C-130J SMOKE DETECTOR

IMPROVED RELIABILITY

C-130J IMPROVED SMOKE DETECTOR RELIABILITY

Proposed New Design

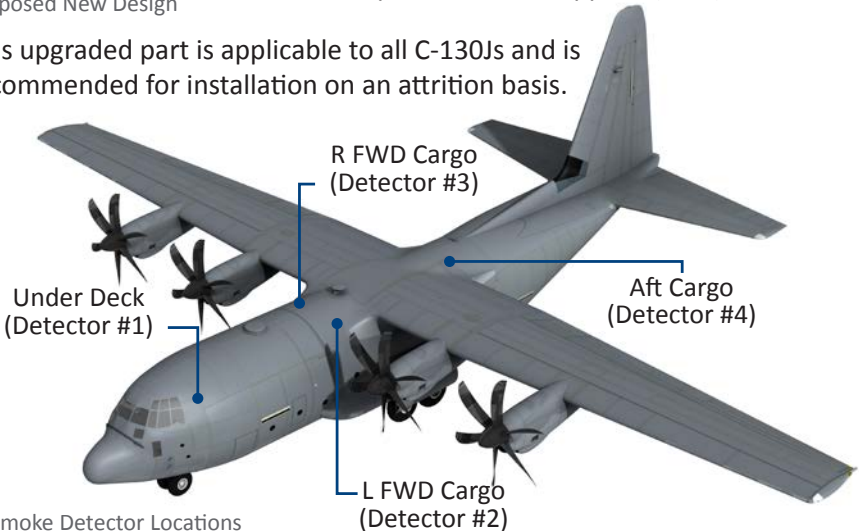
The proposed new design from Kidde Aerospace is a form, fit, and function replacement for the current part. The new design detector includes a metal cover with improved bonding to the base of the unit, eliminating the need for the special bonding strap on Detector #1 and restoring complete interchangeability. Furthermore, the new cover is a more enclosed design that will likely reduce contamination. The new unit is more maintainable by the supplier at the piece part level, reducing repair costs. The new part is expected to be more reliable, resulting in fewer returns, fewer man-hours spent troubleshooting and replacing units, and saving the customer operations and support (O&S) costs.

This upgraded part is applicable to all C-130Js and is recommended for installation on an attrition basis.
